# UNITED STATES PATENT AND TRADEMARK OFFICE

APPLICATION NO.	FILING DATE	FIRST NAMED INVENTOR	ATTORNEY DOCKET NO.	CONFIRMATION NO.
10/517,321	08/23/2005	Per Mansson	Mans3012/REF	3651

# Office Action Summary

## **DETAILED ACTION**

Fig.2

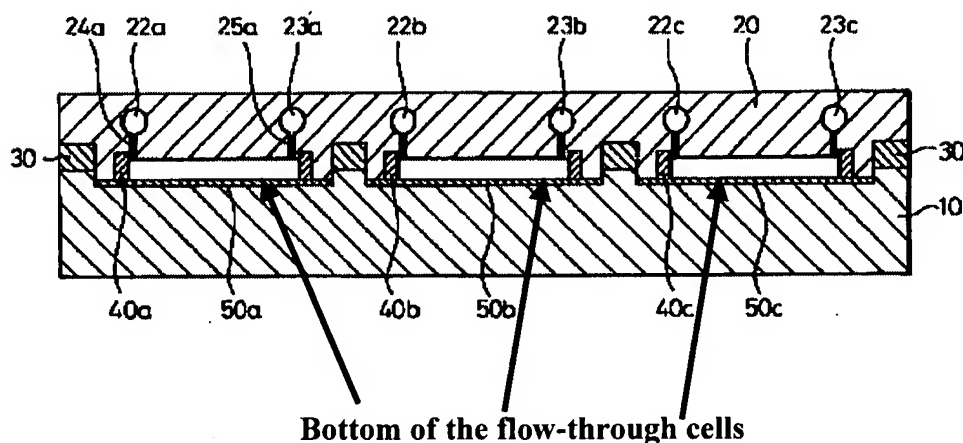
Applicant's interpretation of the element 10 of Kawakami et al. (in Fig.'s 2 and 3), which serves as both connecting panel and the bottom of the flow-through cell is not found persuasive. Applicant correctly interprets that element 10 of Fig.'s 2 and 3 represents connecting panel. However, the bottom of the flow-through cells is not represented by element 10 of Fig.'s 2 and 3 but rather by 50a. This is more clearly illustrated in annotated Fig. 2 below:

Kawakami et al. teaches a flow-through cell as illustrated in Fig. 2 above, in which entrance and exit holes, 22b and 23b, respectively (column 8, lines 32-40), provide flow through cell compartments, which also house the oscillators (50a-c). Therefore, one of ordinary skill in the art would reasonably interpret that the each cell compartment of Fig. 2 as a flow-through cell, which encases the piezoelectric crystal microbalances.

Applicant's argument that connecting panel 10 of Kawakami et al. does not have pair of fluid connecting ports located within the connector portion is acknowledged. However, both elements 110 and 20 of Kawakami et al.'s (see Fig. 2 above) can be interpreted as the connecting station, which has the fluid connecting ports located within element 20.
